Chatfield Farms Active Adult Community

Beacon Falls, Connecticut

King's Mark Environmental Review Team Report

July 2004

Figure 11

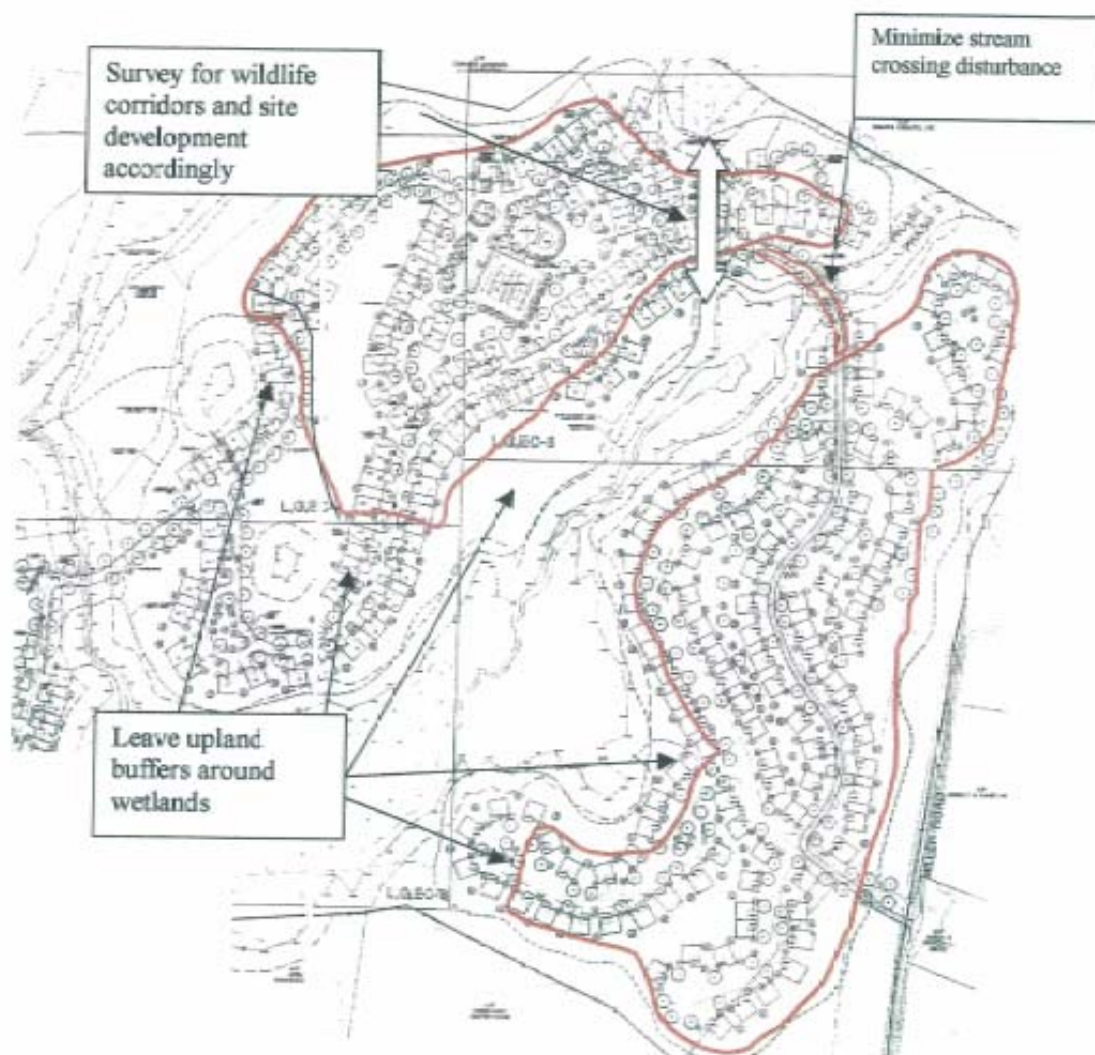
- 11) Limit disturbances within 750 of vernal pools and the wooded swamp to a maximum of 25% of the area so that 75% of the area within 750 of the pool is undisturbed and the disturbed area is limited to within one quadrant of the area within 750 feet. (See Figure 11).

Figure 14

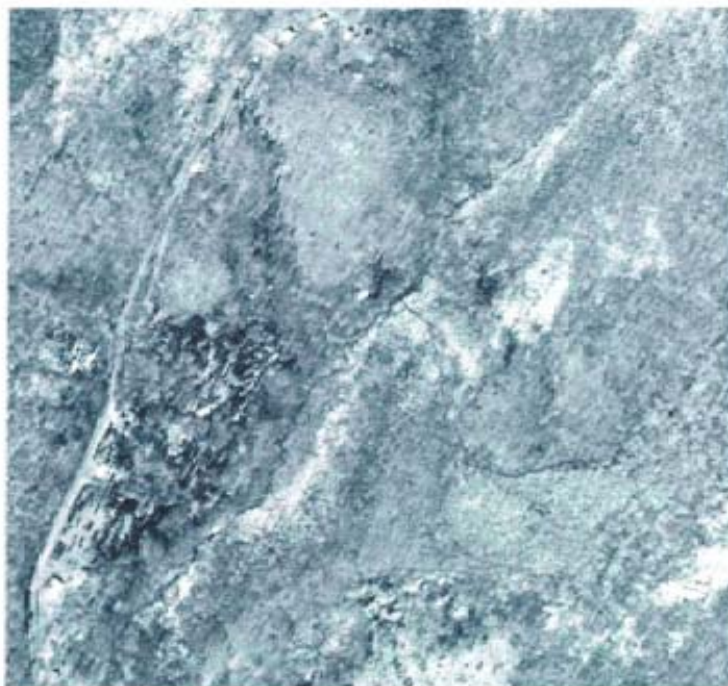
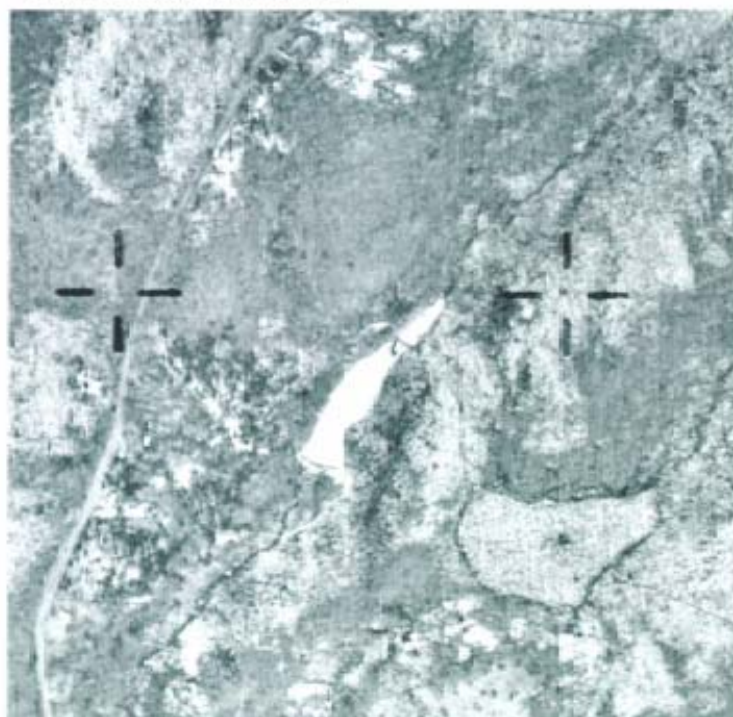
As seen in the two contrasting aerial photographs (Figure 14), in March of 1965 the dam was not in place and it does not appear that construction was about to begin. In the March, 1970 aerial photograph the dam and pond are not only in place but have the appearance of being well established by that time. Until a more definite record can be located, a reasonable estimation would be that the Shaw Dam Pond was built in 1968 plus or minus one year making it roughly 36 years old at the time of the field walk.

Figure 15

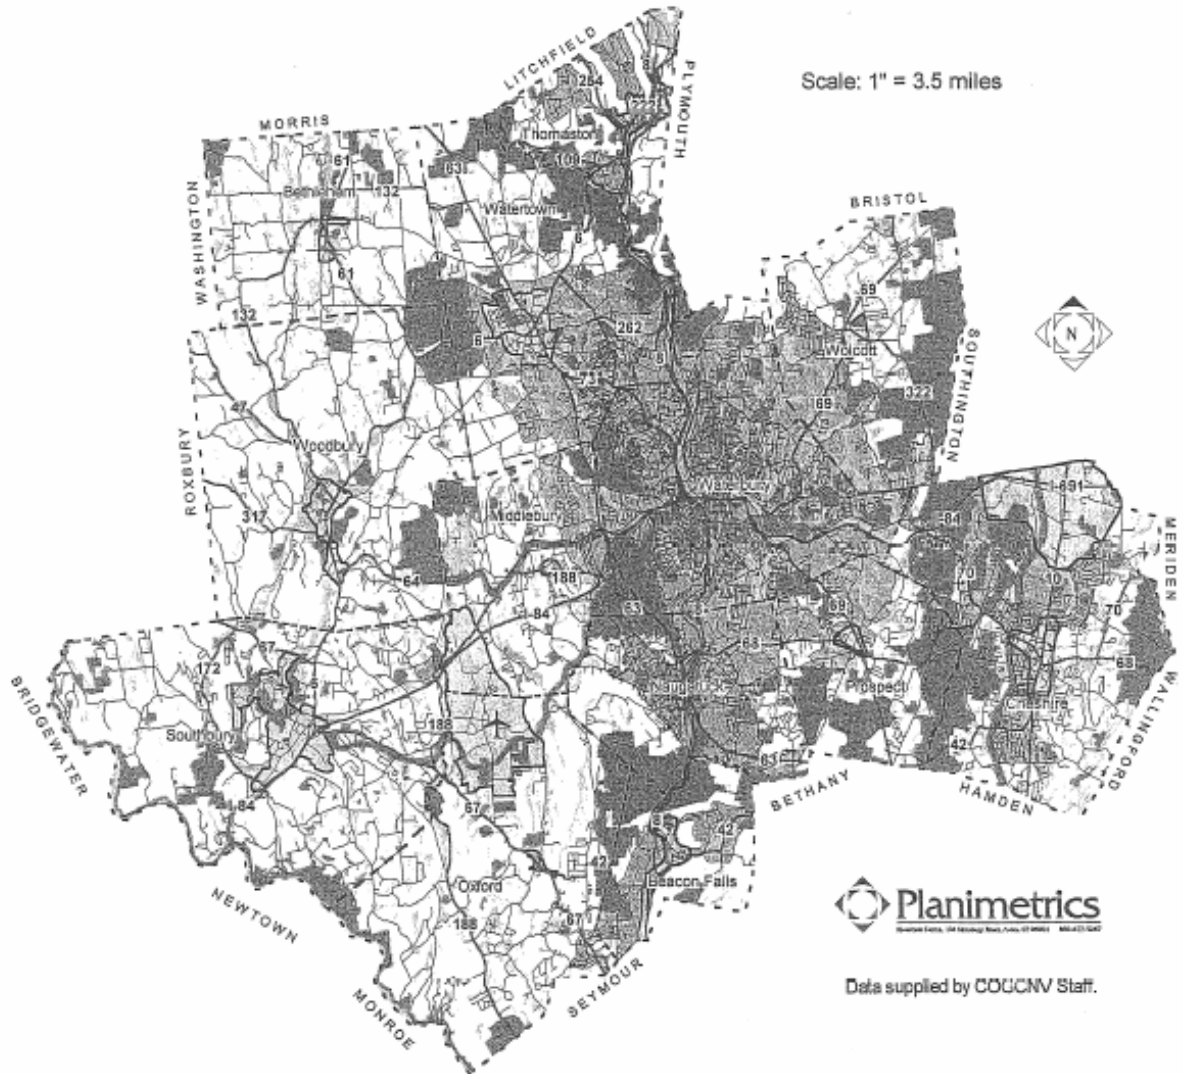
Based on the Future Land Use Map (Figure 15) the proposed development site is recommended for conservation as a Rural Area. Any development, within a Rural Area, should respect natural resource and environmental constraints. Low-density residential development is an acceptable land use for rural areas, according to the Regional Plan. However, the plan does not recommend the extension of public infrastructure into rural areas because densities are too low to efficiently serve with the infrastructure. The benefits of serving low-density development do not exceed the expense of extending public sewer and water lines. The Regional Plan advocates reducing the impacts of sewer discharges. This can be accomplished by using existing infrastructure to guide future growth and encouraging private maintenance of septic systems.
